SUBJECT: Forwards site mod package containing drawings of mods to  
 sampling point for TSC intake ventilation monitor, per  
 discussion during Emergency Preparedness Insp 50-528/87-22,  
 50-529/87-22 & 50-530/87-23.

**FOR INFORMATION ONLY**  
PVNGS  
**SITE MODIFICATION**

This site mod is a partial of PCR 87-HN-001. The scope of work is to relocate the sample point of radmonitor AJSQNRU13A from a point in the duct which does not sample TSC office air during emergency mode to a point of recirculation.

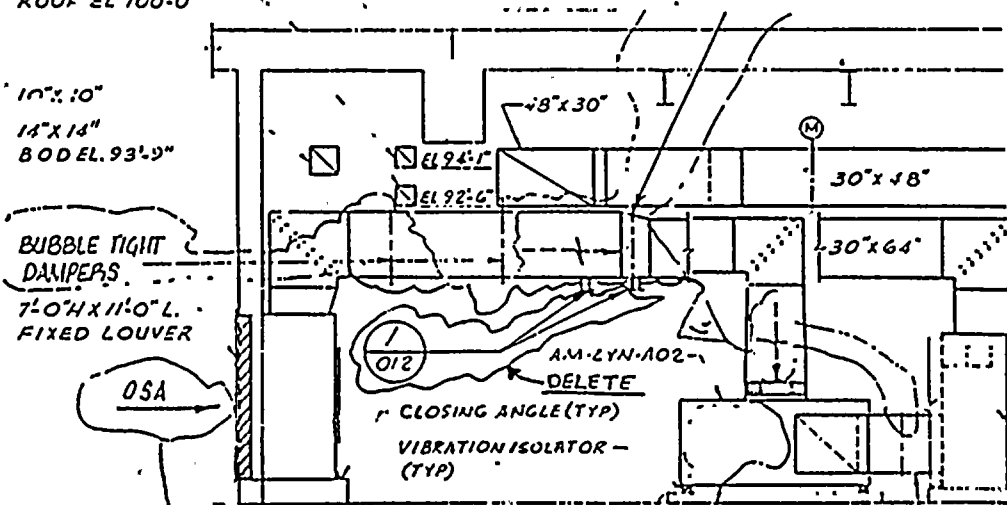
<b>ANPP</b>	<b>FIELD CHANGE REQUEST (FCR)</b>	FCR # <b>A-A-5191</b>	PAGE <b>1</b> OF <b>1</b>
	QUALITY CLASS <b>S</b>	DATE (MO/DAY/YR) <b>4/17/87</b>	SCH/DCN/SDCN # <b>4</b>
REF DWG OR SPEC <b>AO-A-ZYD-196 Rev 4</b>	REV. # <b>5</b>	TITLE: <b>TECHNICAL SUPPORT CENTER HVAC TEMPERATURE CONTROL DIAGRAMS</b>	
DESIGN ORGANIZATION <input checked="" type="checkbox"/> NE <input type="checkbox"/> NO <input type="checkbox"/>		<input type="checkbox"/> UNIT 1 <input type="checkbox"/> UNIT 3 <input type="checkbox"/> WRF	<input type="checkbox"/> UNIT 2 <input checked="" type="checkbox"/> COMMON <input type="checkbox"/> OTHER
REQUESTED BY <input type="checkbox"/> NC <input type="checkbox"/> NO <input type="checkbox"/> NE <input checked="" type="checkbox"/> <b>N.A.</b>		AFFECTED UNIT(S) FOR AS-BUILT KEY DWGS.	
DCP # <b>SITE MGD</b> <b>A-SM-HN-002</b>		PCR/PCP # <b>87-AO-HN-001</b>	
EXISTING CONDITION <b>Radiation Sample Probes are located in an improper location.</b>

FCR NO.: P-A5192

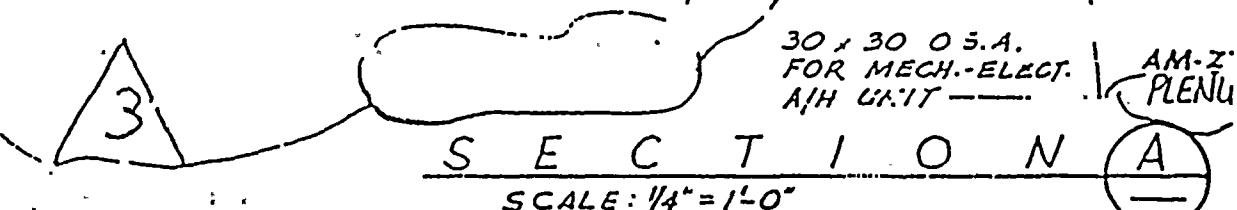
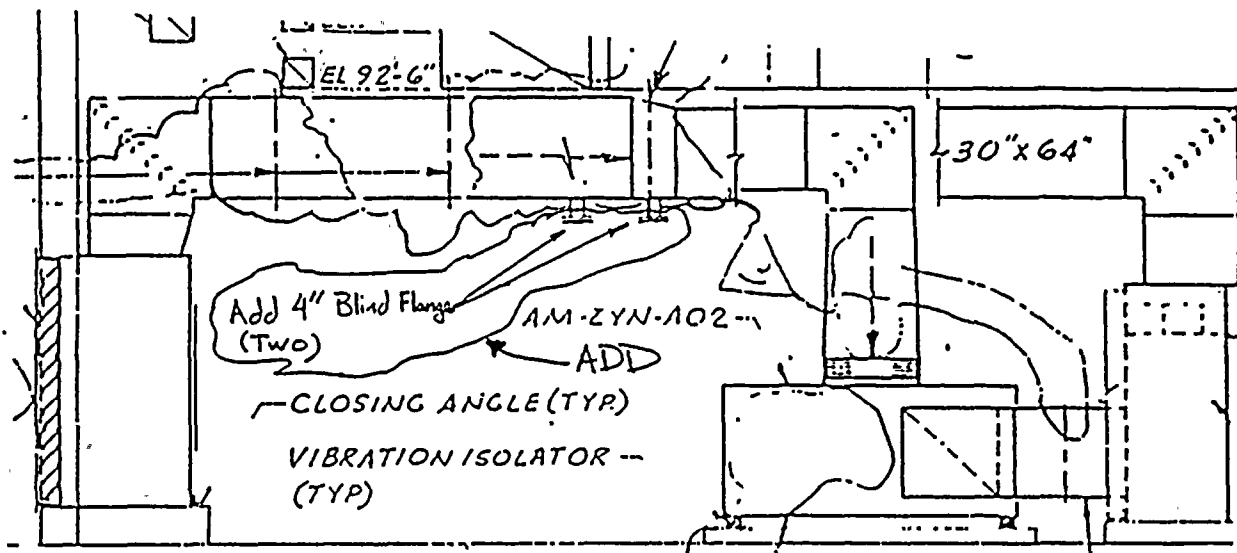
ADD THE FOLLOWING AT COORDINATE D-3:

FCR NO.: PA5192 Page 3 of 4

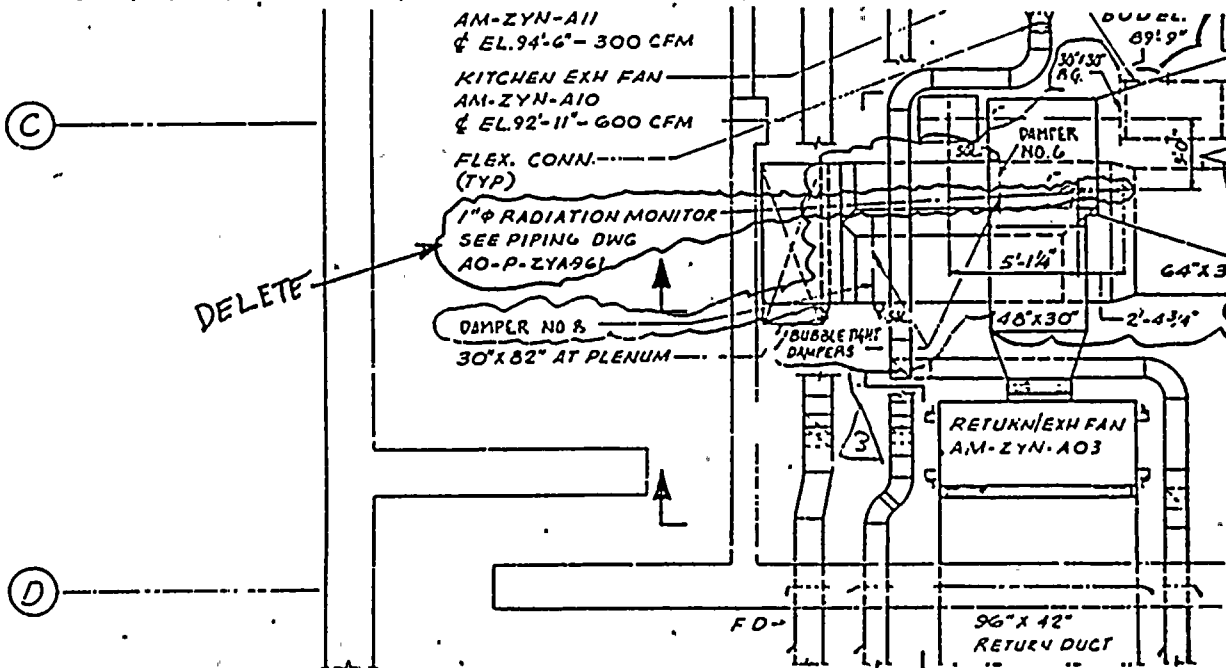
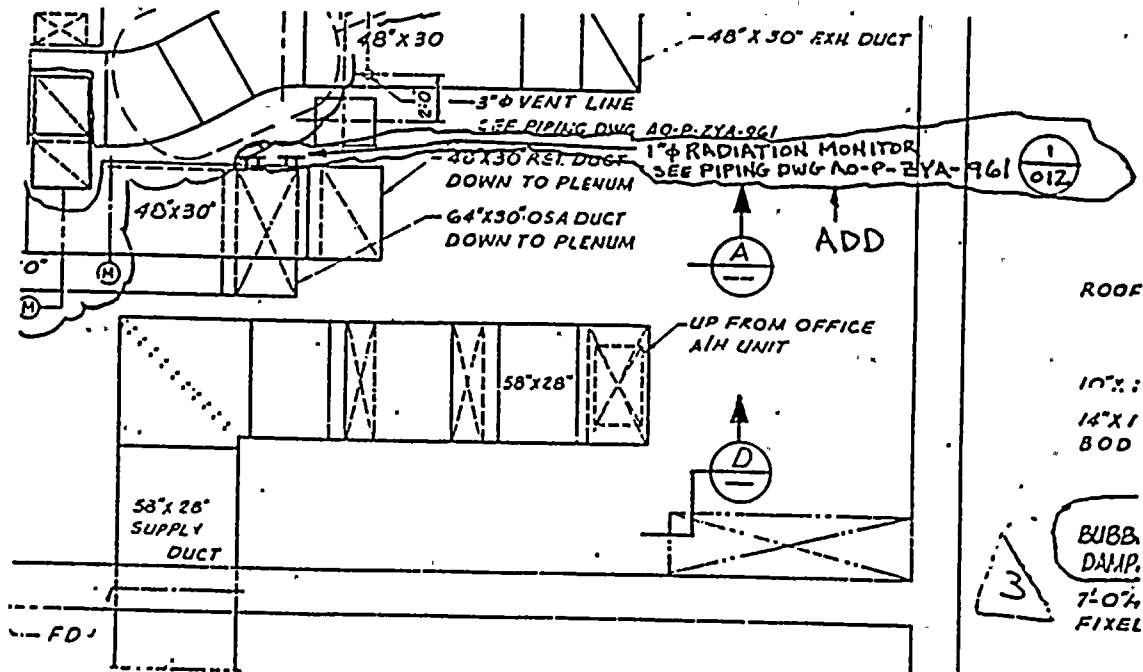
**DELETE THE FOLLOWING AT COORDINATE E-7:**

**ADD THE FOLLOWING AT COORDINATE E-S:**

FCR NO.: PA5192

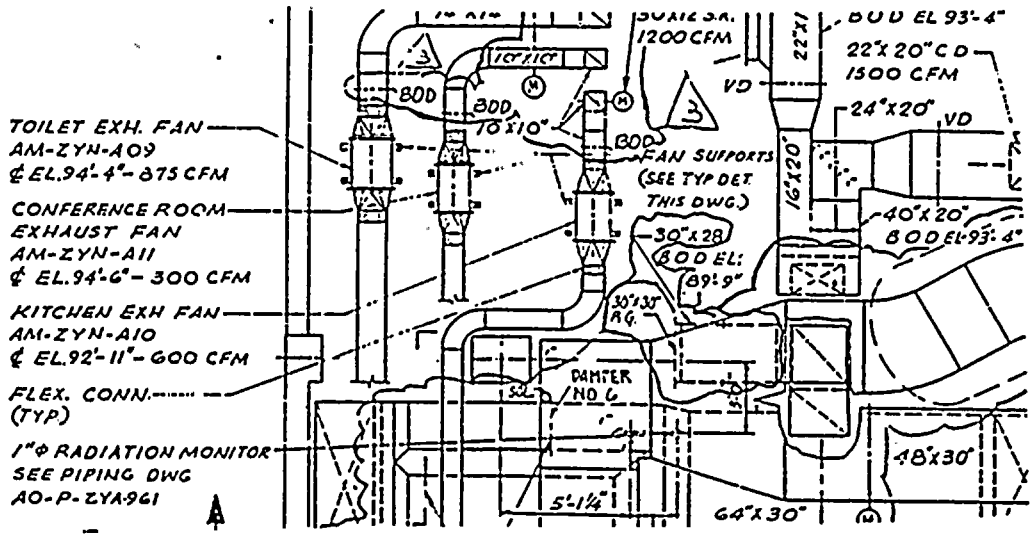
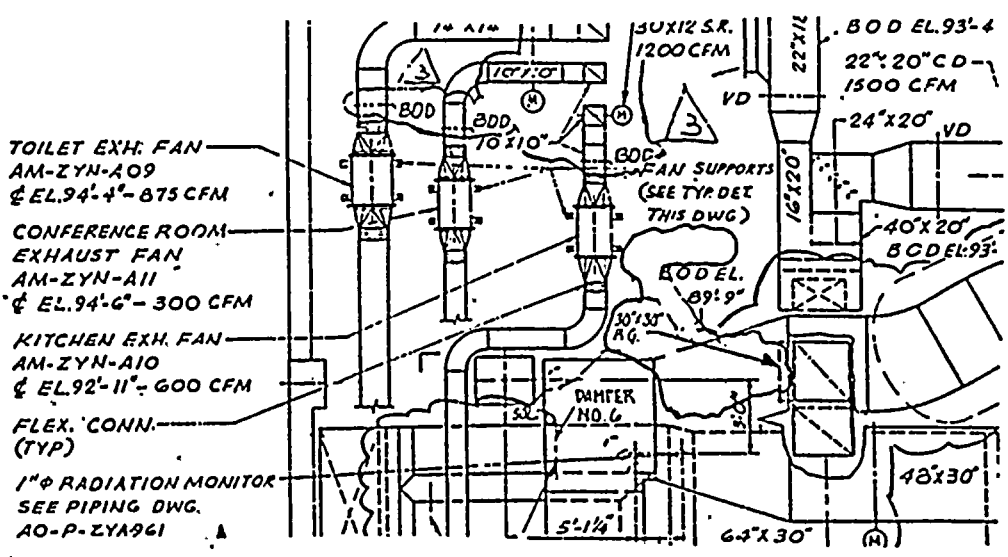
ACTUAL LOCATION OF 30"X30" REGISTER IS SHOWN IN THE WRONG LOCATION AT COORDINATE E-6

CHANGE FROM:

CHANGE TO:

FCR NO: P-A-5193

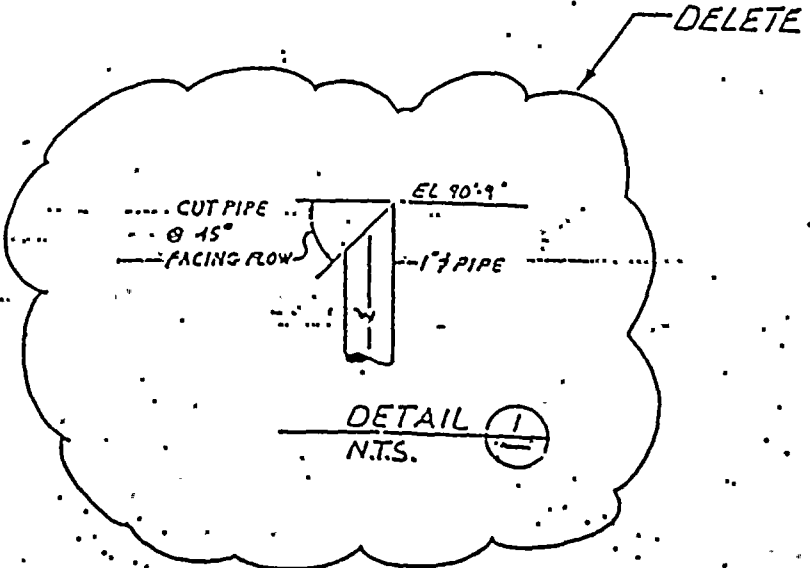
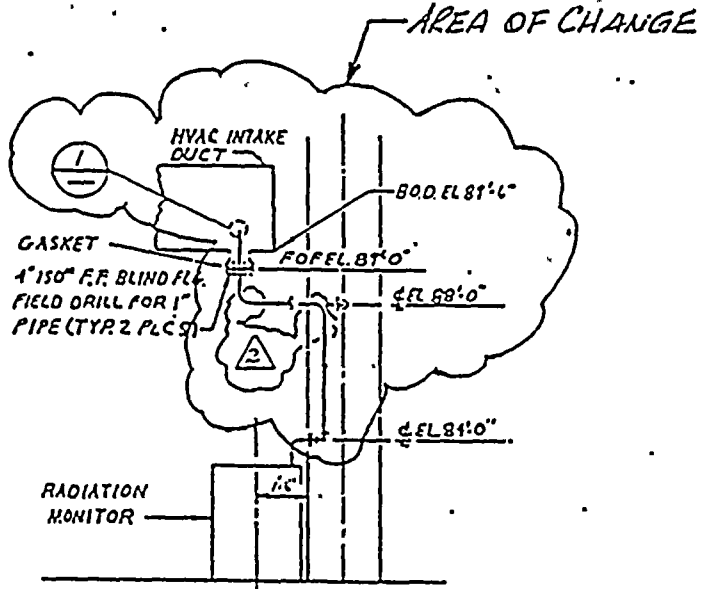
CHANGE REQUEST/SKETCH <p style="text-align: center; font-size: 1.2em; border: 1px solid black; padding: 5px;">                     RELOCATE RADIATION MONITOR SAMPLE PIPING FROM OUTSIDE AIR SUPPLY DUCT TO REIRC. DUCT.                 </p>			
PROJECT IMPACT: <input type="checkbox"/> SCHEDULE <input checked="" type="checkbox"/> COST <input type="checkbox"/> _____			
PREPARED BY (PLEASE TYPE OR PRINT) <b>Wayne Dabberpohl</b>		PHONE <b>4076</b>	DATE <b>4/17/87</b>
REQUESTOR DEPT. <b>NA</b>		A/E DISPOSITION <b>N/A</b>	
A <b>NA</b> REVIEWED BY (SIGNATURE) _____ DATE _____		B <b>NA</b> REVIEWED BY (SIGNATURE) _____ DATE _____	
B <b>NA</b> CONCURRED BY (SIGNATURE) _____ DATE _____		C <b>NA</b> APPROVED BY (SIGNATURE) _____ DATE _____	
A <b>Wayne Dabberpohl</b> NUCLEAR ENGINEERING REVIEWED BY (SIGNATURE) _____ DATE <b>4/17/87</b>		A <b>William Smith</b> PVNGS ENGINEERING REVIEWED BY (SIGNATURE) _____ DATE <b>4/15/87</b>

EXISTING CONDITION

ZONE: F-6

FCR NO.: P-A 5193

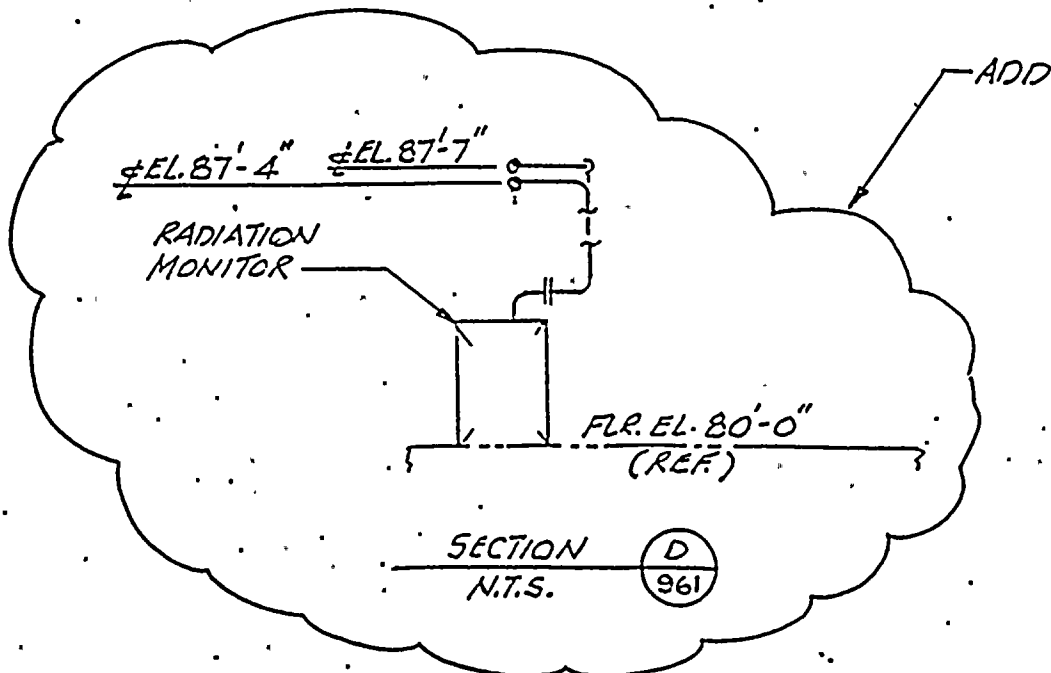
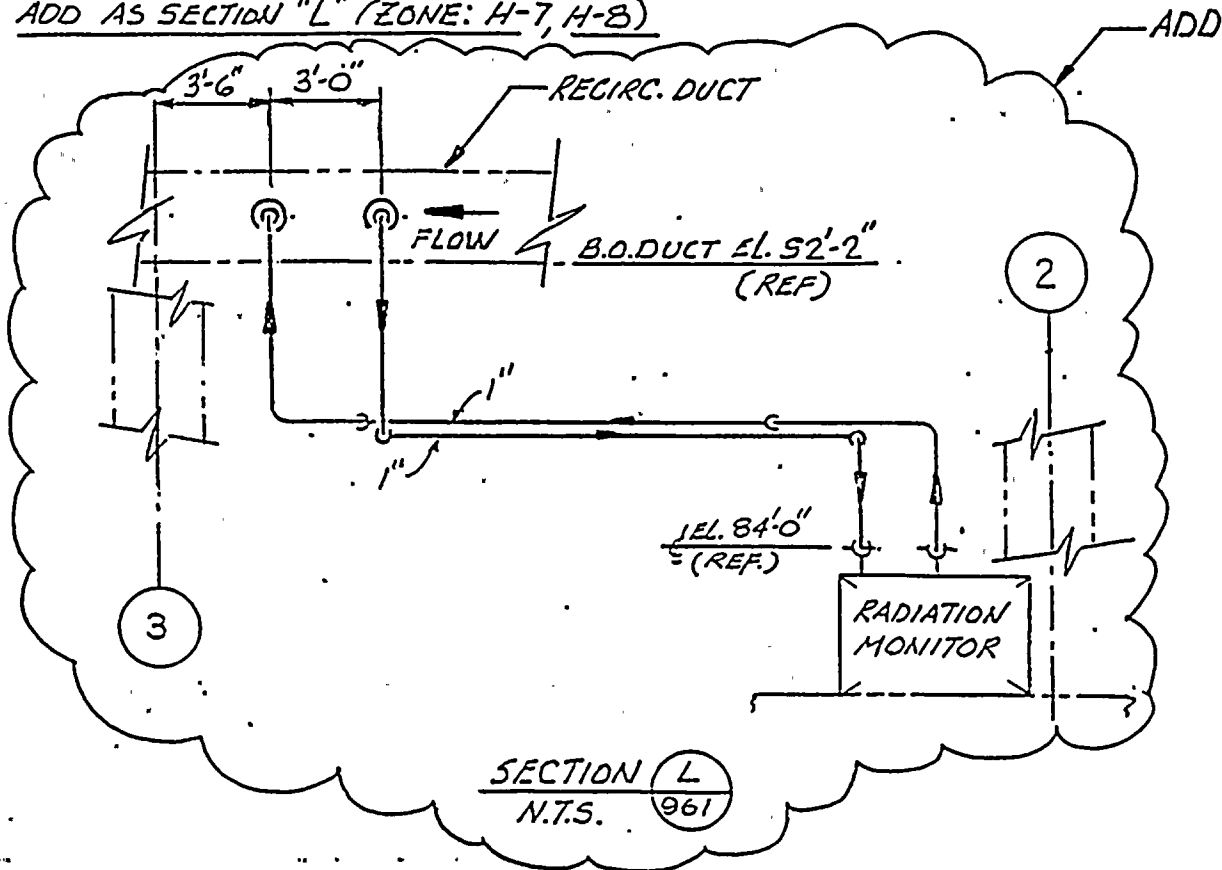
CHANGE TO CONDITION:

ADD AS SECTION "L" (ZONE: H-7, H-8)

FCR NO: P-A5194

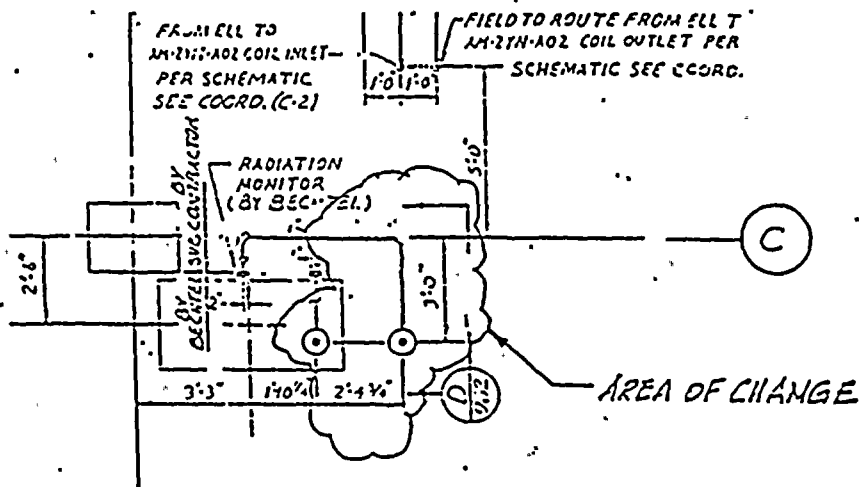
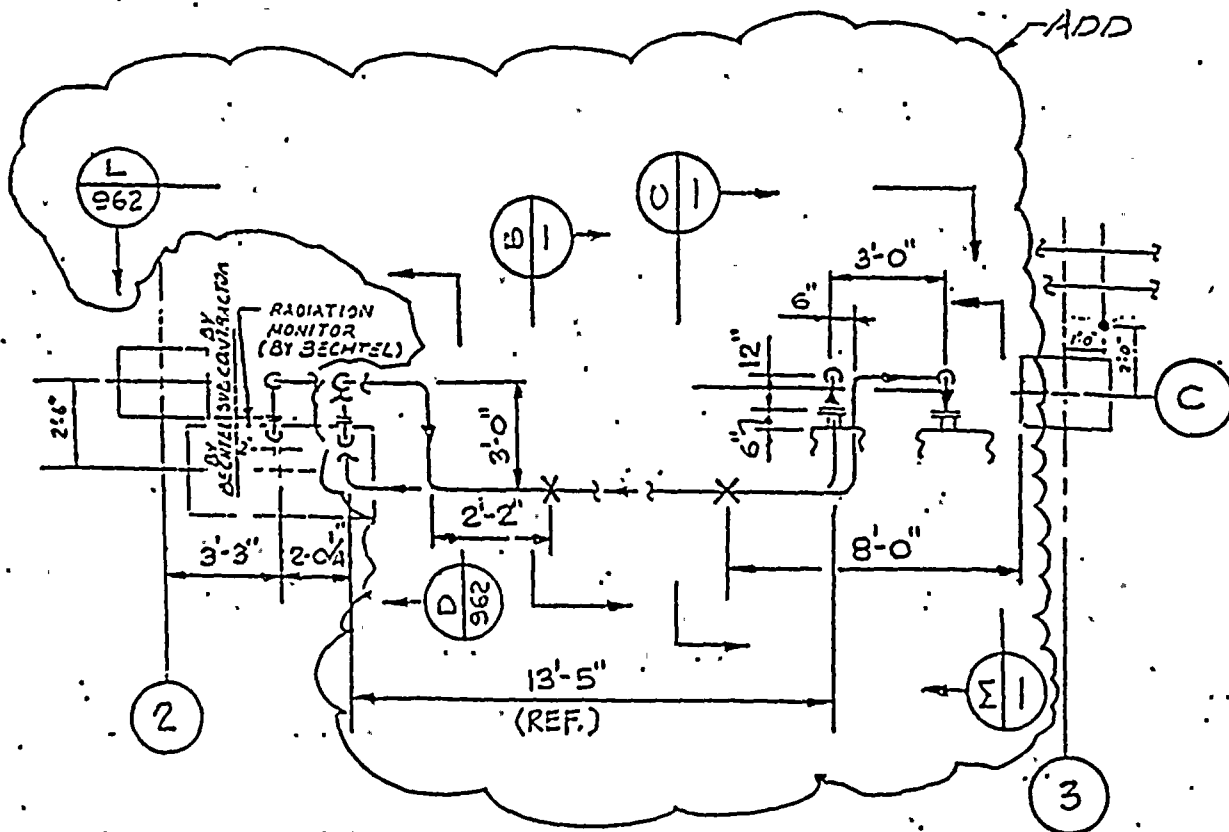
CHANGE REQUEST/SKETCH <p style="text-align: center; font-size: large; text-decoration: underline;">RELOCATE RADIATION MONITOR SAMPLE PIPING FROM OUTSIDE AIR SUPPLY DUCT TO RECIRC. DUCT.</p>			
PROJECT IMPACT: <input type="checkbox"/> SCHEDULE <input checked="" type="checkbox"/> COST <input type="checkbox"/> _____			
PREPARED BY (PLEASE TYPE OR PRINT) <b>Wayne Dobberpuhl</b>		PHONE <b>x4076</b>	DATE <b>4/15/87</b>
REQUESTOR DEPT.		A/E DISPOSITION	
A <b>N/A</b> REVIEWED BY (SIGNATURE)   _____   DATE _____		A <b>N/A</b> COMPANY   _____	
B <b>N/A</b> REVIEWED BY (SIGNATURE)   _____   DATE _____		B <b>N/A</b> REVIEWED BY (SIGNATURE)   _____   DATE _____	
C <b>N/A</b> CONCURRED BY (SIGNATURE)   _____   DATE _____		C <b>N/A</b> APPROVED BY (SIGNATURE)   _____   DATE _____	
A <b>Wayne Dobberpuhl</b> NUCLEAR ENGINEERING <b>Frax</b> REVIEWED BY (SIGNATURE)   _____   DATE <b>4/17/87</b>		A <b>W. K. ...</b> PVNGS ENGINEERING REVIEWED BY (SIGNATURE)   _____   DATE <b>4/30/87</b>

EXISTING CONDITION

ZONE:-(C-6)

CHANGE TO CONDITION

ZONE:-(C-4, C-5 & C-6)

FCR NO: P-A51A

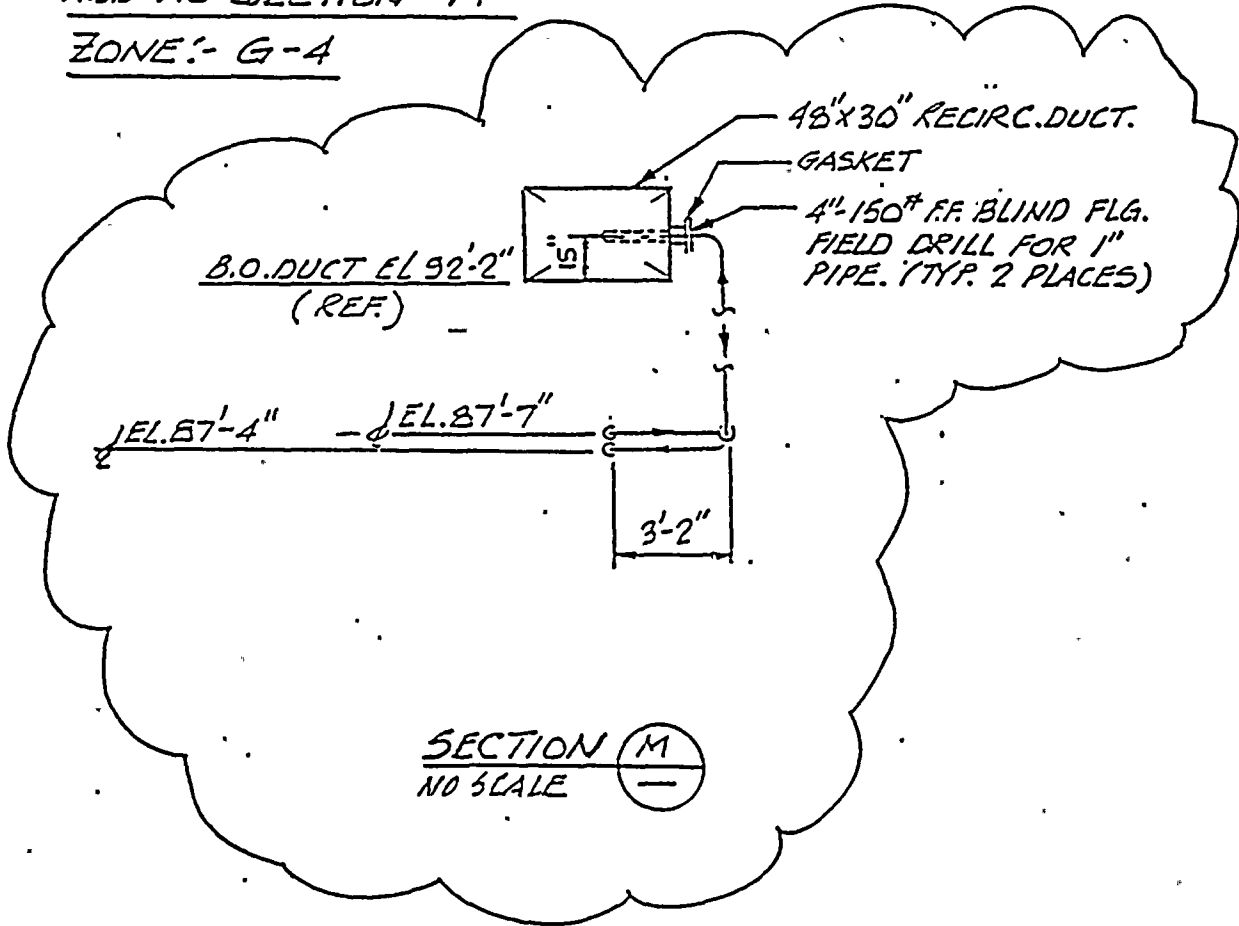
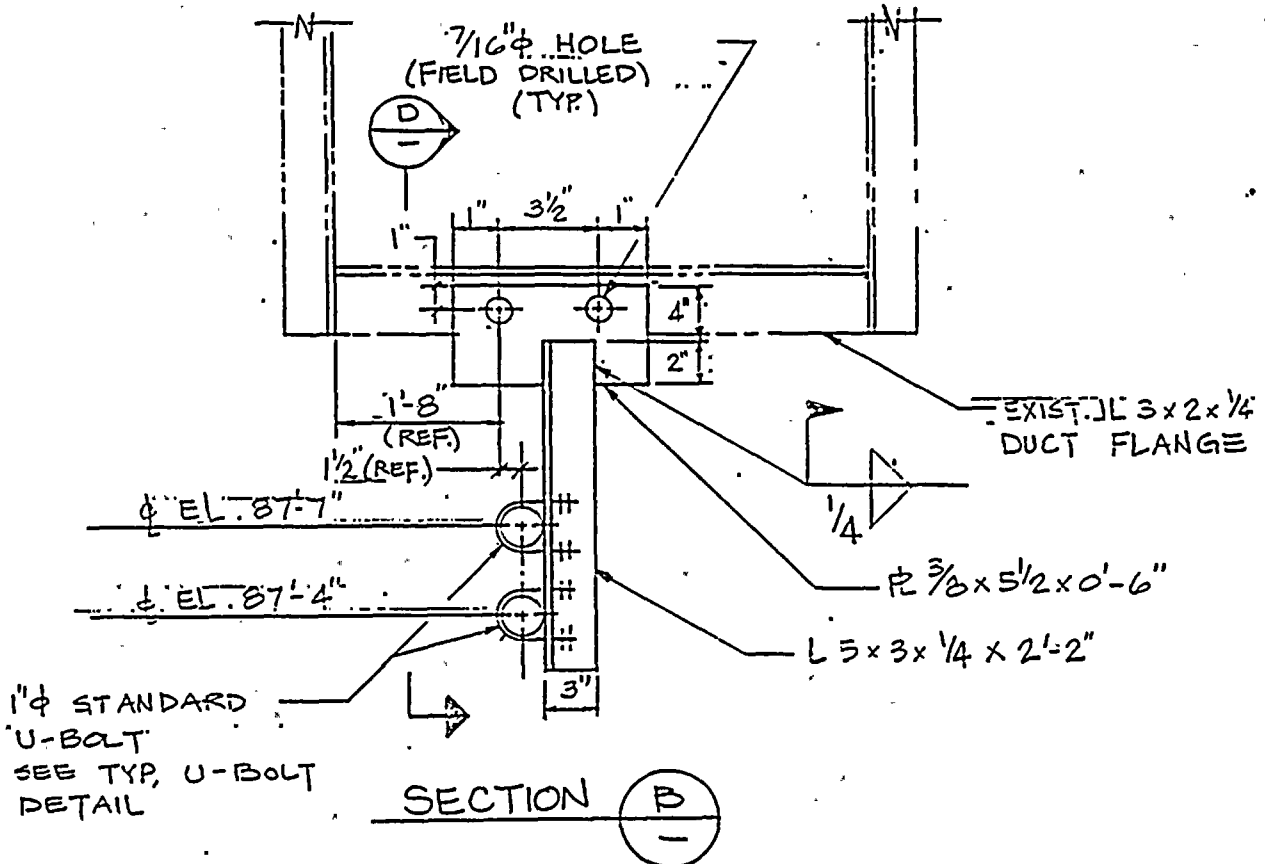
CHANGE TO CONDITION.

ADD AS SECTION "M"

ZONE:- G-4
